Access Compliance Report

Public Rights-of-Way

Intersection ID: 23302	Main Street: COLONY_RD	Cross Street: MORROWICK_RD	Location: NE
ADA ID: DB4946B08C8E	Ramp Type: PerpDiag	Initial Pass/Fail: Fail	Overall Compliance: No
		Severity Score: 37.5

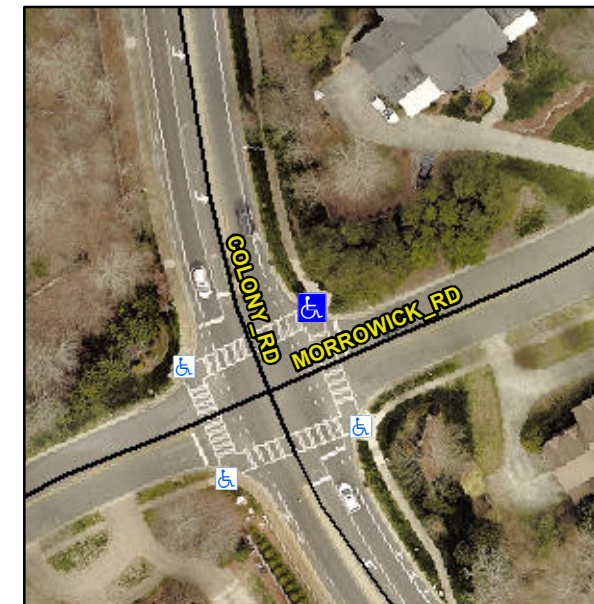
Not Found, R304.2.2, R304.5.3

Compliance	Description	Data	Compliance	Description	Data
N/A	Ramp Length (in)	74.0	No	Ramp Slope (%)	8.8
Yes	Ramp Width (in)	53.0	No	Ramp XSlope (%)	8.5
N/A	Flare Type LT	N/A	N/A	Flare Type RT	N/A
N/A	Flare Slope LT (%)	N/A	N/A	Flare Slope RT (%)	N/A
N/A	Flare Traversable LT?	N/A	N/A	Flare Traversable RT?	N/A
N/A	Landing Length (in)	N/A	N/A	DWS Provided?	N/A
N/A	Landing Width (in)	N/A	N/A	DWS Contrast?	N/A
N/A	Landing Slope (%)	N/A	N/A	DWS Length (in)	N/A
N/A	Landing X Slope (%)	N/A	N/A	DWS Full Width?	N/A
N/A	Landing Curb? (Y/N)	N/A	N/A	DWS Offset (in)	N/A
N/A	Shared Landing?	N/A			
N/A	Gutter Ponding?	N/A	N/A	Gutter Slope (%)	N/A
N/A	Gutter Lip Ht (in)	N/A	N/A	Gutter X Slope (%)	N/A
N/A	Painted X Walk1?	Yes	N/A	Painted X Walk2?	Yes
	X Walk 1 Direction	To SW		X Walk 2 Direction	To SE
N/A	X Walk 1 Width (in)	112.0	N/A	X Walk 2 Width (in)	107.0
	X Walk 1 Slope (%)	1.6		X Walk 2 Slope (%)	5.2
	X Walk 1 X Slope (%)	4.7		X Walk 2 X Slope (%)	2.6

Remove & Replace Curb Ramp With Two New Directional Ramps or Equivalent.
